APPLICANT: Gulf States Utilities Company (GSU)  
FACILITY: River Bend Station (RBS)  
SUBJECT: SUMMARY OF MEETING TO DISCUSS REACTOR SHIELD BUILDING SHEAR REINFORCEMENT

RIVER BEND UNIT 1  
CONTAINMENT SHIELD BUILDING  
SHEAR REINFORCING Z BAR ANCHORAGE

FIGURE 1

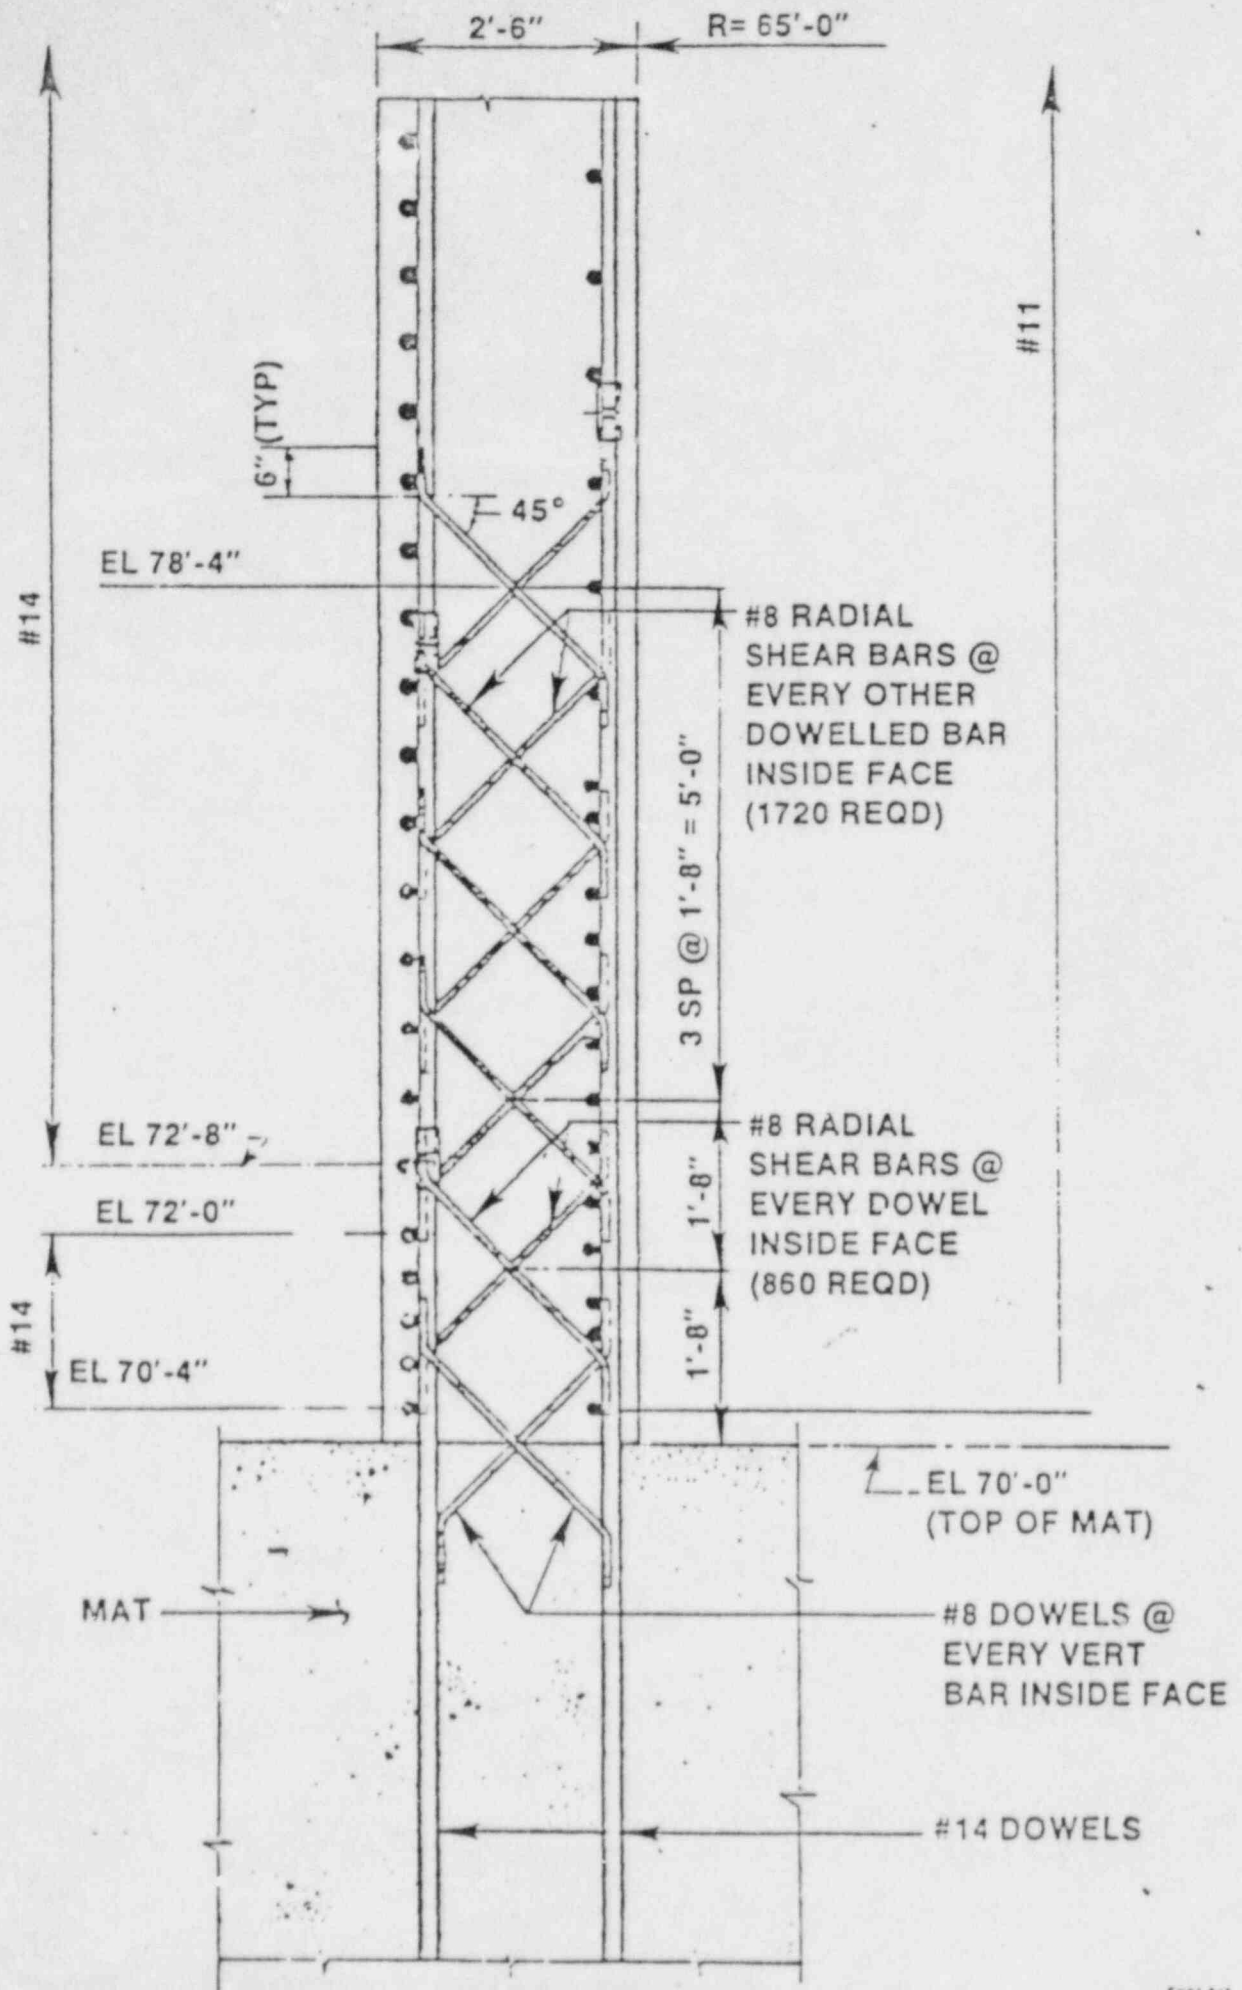
Questions were raised by the staff during an IDI audit of April 23, 1984, regarding the adequacy of the development length of these Z bars. This development length is required to properly anchor the bars so that the tensile forces can be developed. To answer these questions the applicant presented the justification for the procedure used to compute the development length of these radial shear bars in a meeting held in Bethesda, MD. on June 20, 1984. The radial shear reinforcing bars are Z shaped with the main portion of the bar 45 degrees to the horizontal with a portion bent so that it is vertical and parallel to the vertical reinforcing bars in the inside and outside face of the Shield Building wall. One end of the bar is bent upward and the other end is bent downward, refer to Figure 1 for more details.

The calculations for Shield Building wall used a different procedure for determining the development length. The Z bars do not entirely comply with the code requirements, particularly the provisions of Section 12.13 of the ACI code. The code requires an effective embedment of  $.5 l_d$  ( $l_d$  is development length) plus a standard hook or an embedment of  $l_d$  calculated or no less than 24 bar diameters as required by section 12.13.1.2 of ACI 318-71 for the anchorage of shear reinforcement. The Z bars provided by the applicant do not employ a standard hook as is required. Instead, a 45 degree bend is provided with a 6 inch length of Z bar parallel to the main reinforcing bars.

The applicant stated during the June 20, 1984 meeting that the Z bars were not needed since the annulus volume between the Shield Building wall and the steel containment shell is filled with concrete. The concrete is 25 feet deep and produces a reduction in the thermal gradient with its accompanying reduction in the radial shear. The applicant concluded that the existing design is acceptable. However, before the staff can reach a conclusion the following four additional pieces of information are required.

1. As stated by the applicant during the Bethesda meeting the demand for shear reinforcing was reduced when the concrete fill between the Shield Building and the containment steel shell was provided which resulted in a reduction in the design temperature from 195 degrees F. to 150 degrees F. The calculations pertaining to the redefinition of the temperature gradient and resulting thermal loads should be summarized and provided to the staff for review.

2. The required reinforcing bar area  $A_v$  prior to the addition of the concrete of the concrete fill was shown by the applicant to be equal to .569 square inches. Calculations pertaining to the determination of the required area before and after the concrete fill was added, should be provided to the staff for review.
3. Explain how the critical section or sections were determined including the rationale for assuring the most critical sections were evaluated.
4. Provide the results of the evaluation for loads on Shield Building wall at the top of the annulus fill concrete at elevation 95'-0".
